Sheet: /
File: MEGA328PB.kicad_sch

Title: NK ZERO

Size: A4	Date: 2025-02-22	Rev: 02
KiCad E.D.A. 8.0.8		Id: 1/1

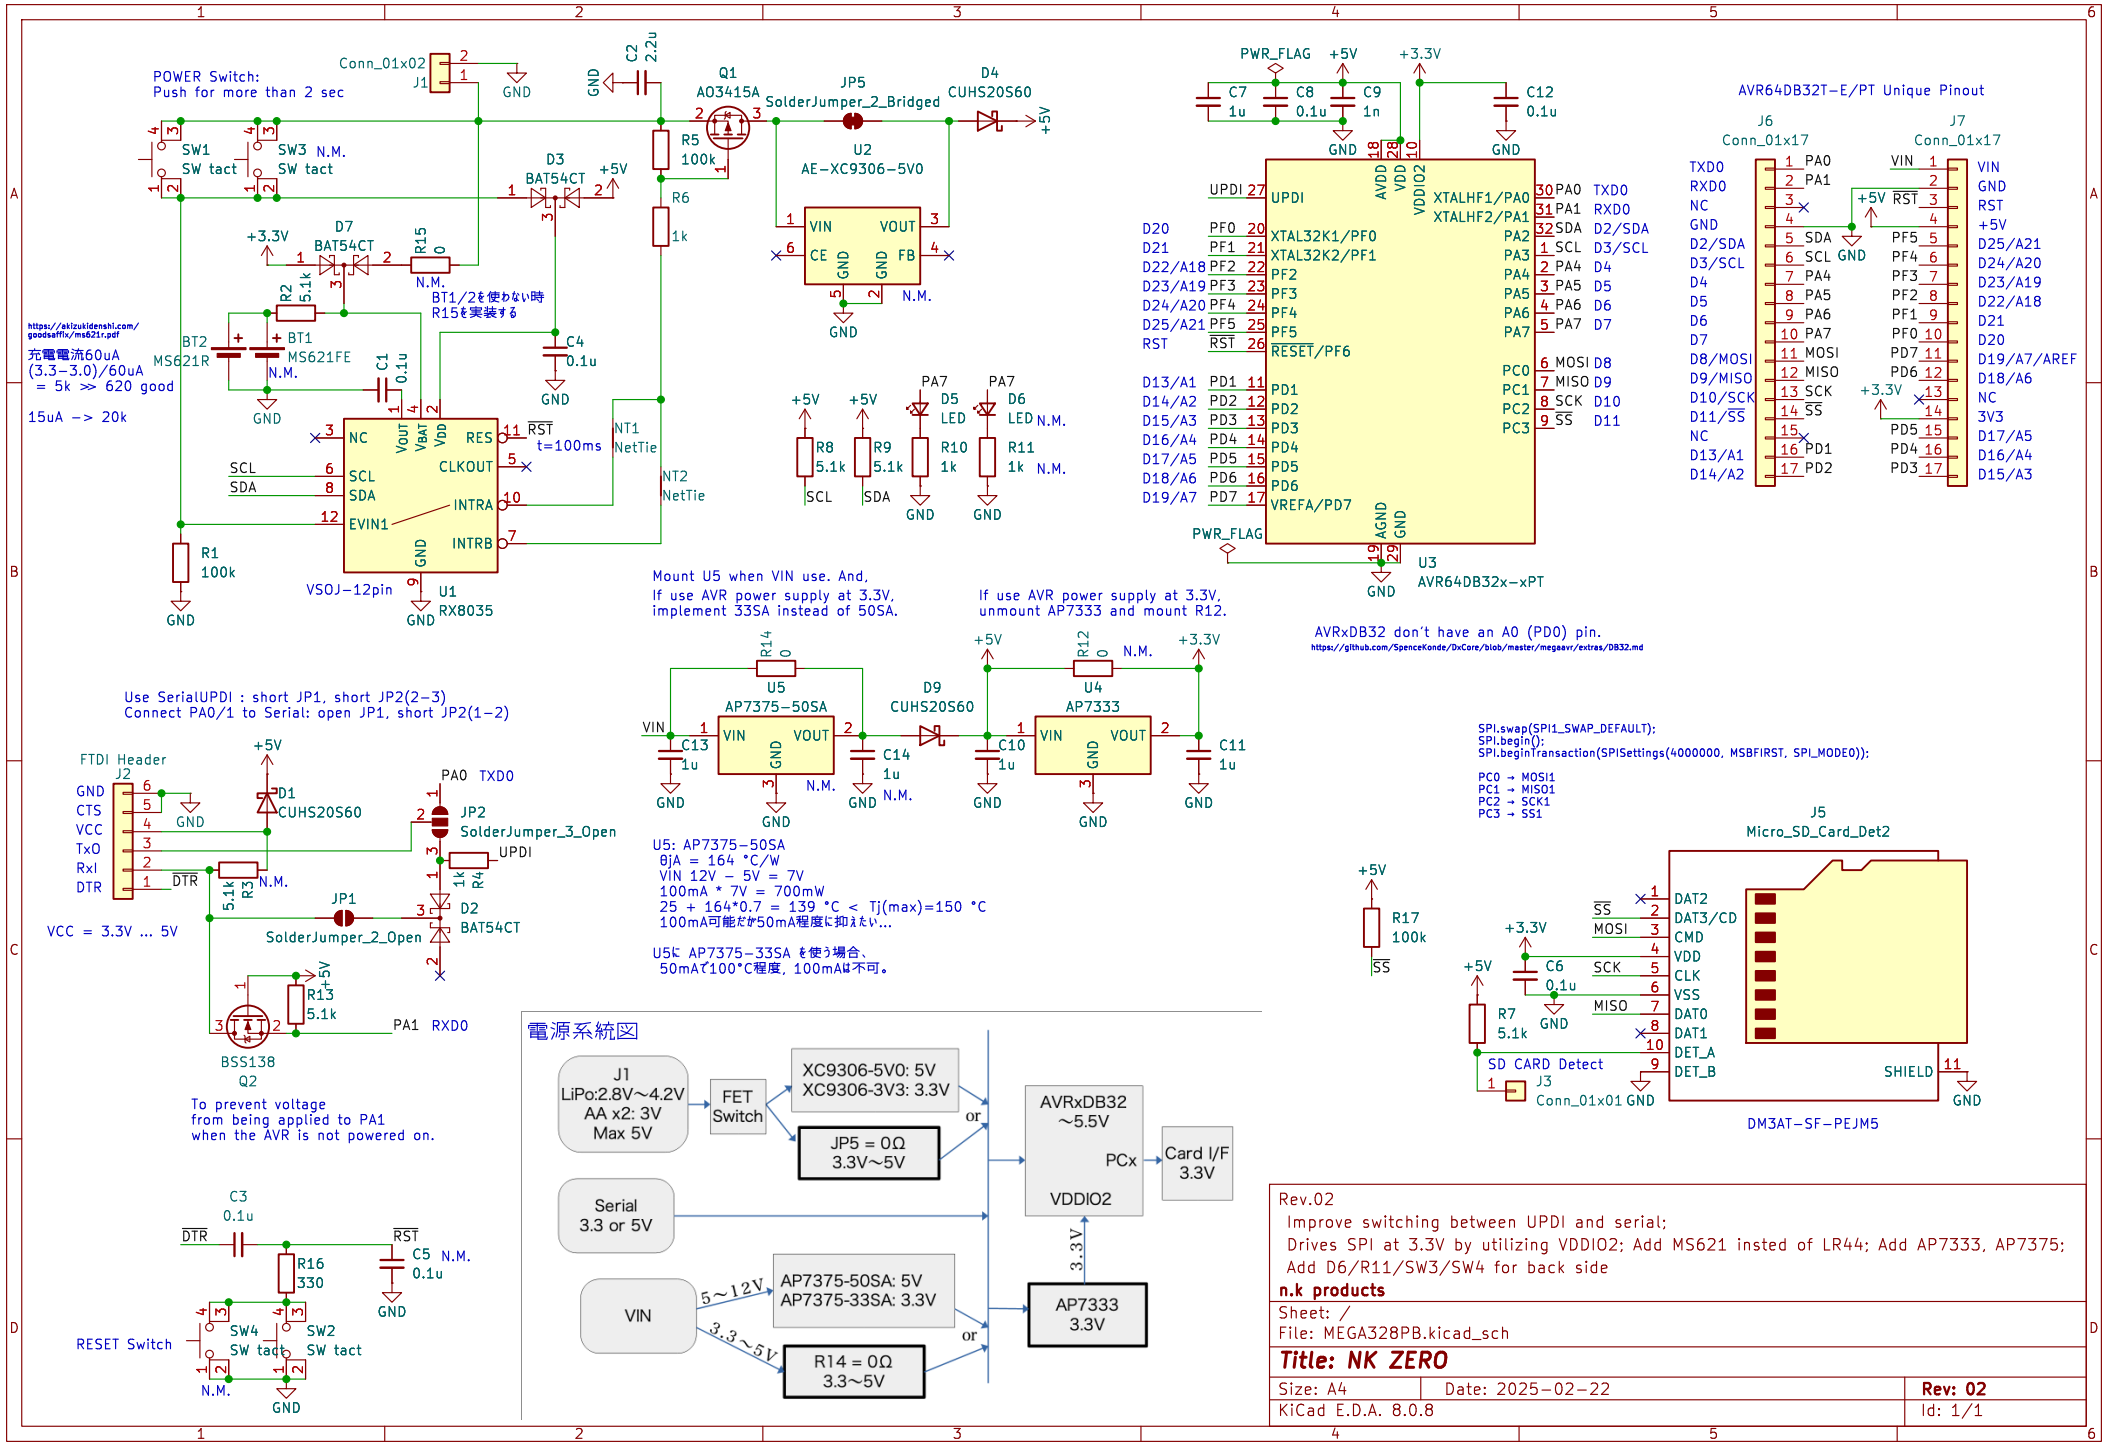
Rev.02
Improve switching between UPDI and serial;
Drives SPI at 3.3V by utilizing VDDIO2; Add MS621 insted of LR44; Add AP7333, AP7375;
Add D6/R11/SW3/SW4 for back side
